AMENDMENT OF SOLICITATION/MODIFICATION OF CONTRACT

2. AMENDMENT/MODIFICATION NO.	3. EFFECTIVE DATE	4. REQUISITION/PURCHASE REQ.NO.	5. PROJECT NO. *(If applicable)*
0002	20 JAN 2004

(X)	
	9A. AMENDMENT OF SOLICITATION NO. FA9101-04-B-0003
X	9B. DATED *(SEE ITEM 11)* 18 DEC 2003
	10A. MODIFICATION OF CONTRACT/ORDER NO.
	10B. DATED *(SEE ITEM 13)*

See attached list of questions received from potential bidders with the government's answers. Also, to clarify the solicitation drawings, four pages of sketches are attached. The bid opening date remains 2:00 local time, 28 January 2004.

SKETCH 1

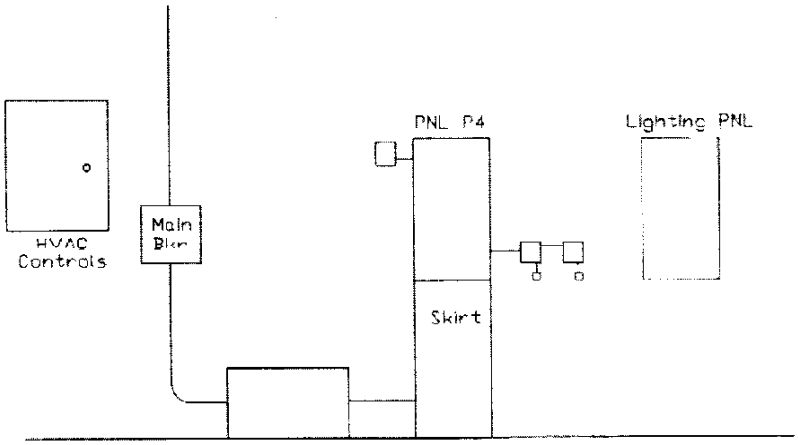
Locations of new panels and power conditioner should be coordinated with building manager and government official present.
If location involves relocation of existing equipment, then this should not be an added cost to the government.
MC cable should be routed from new panels through conduit to existing skirts or new skirts.

SKETCH 2

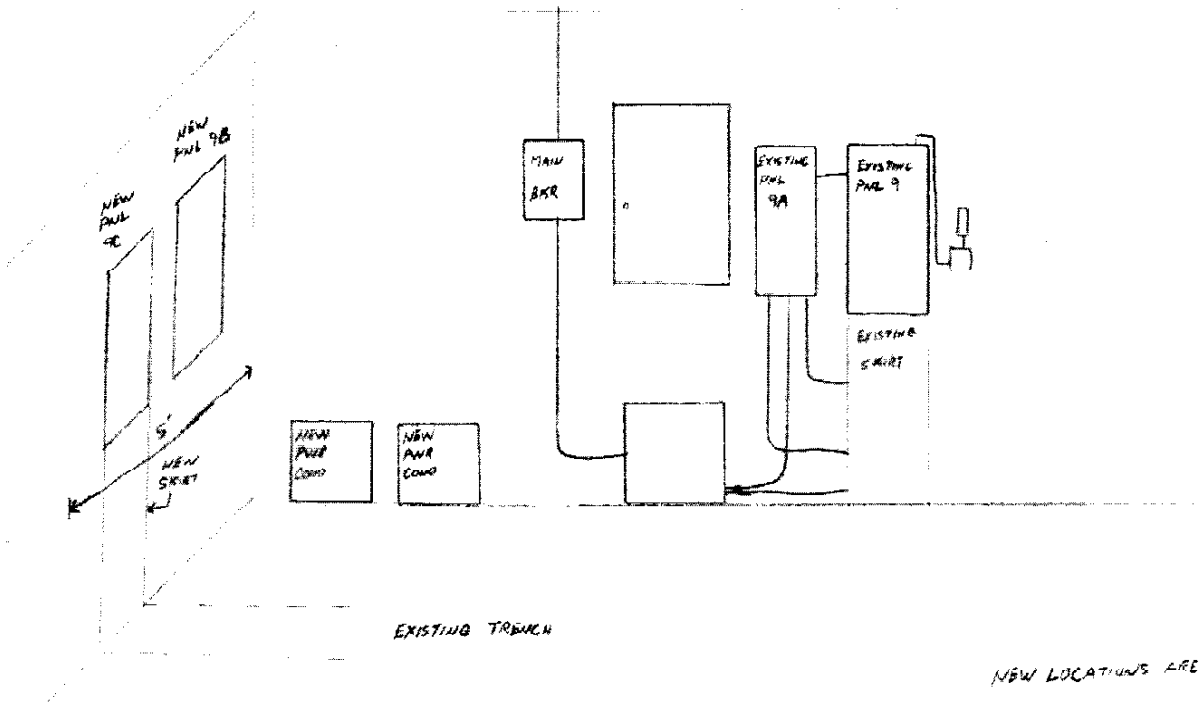
NEW LOCATIONS ARE APPROXIMATE

REFERENCE DWG TBT10344. E2 G-12

PANEL IS NOT TO EXCEED 5' FROM CORNER

NEW LOCATIONS ARE APPROXIMATE

DWG TBT10344.E2 G-7

SKETCH 3

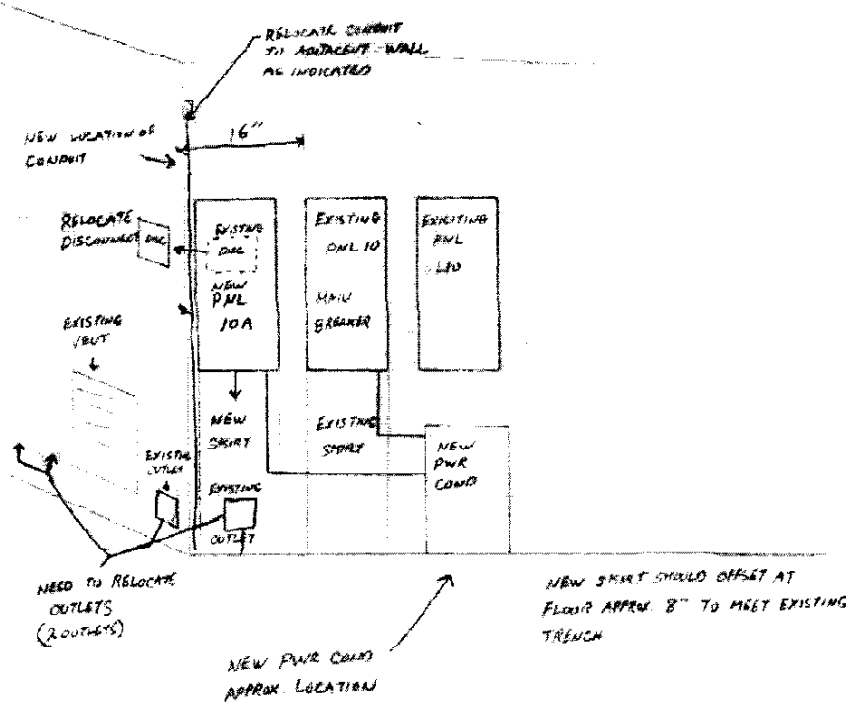
NEW LOCATIONS ARE APPROXIMATE.

REFERENCE DWG T8T10344.E1 D-11
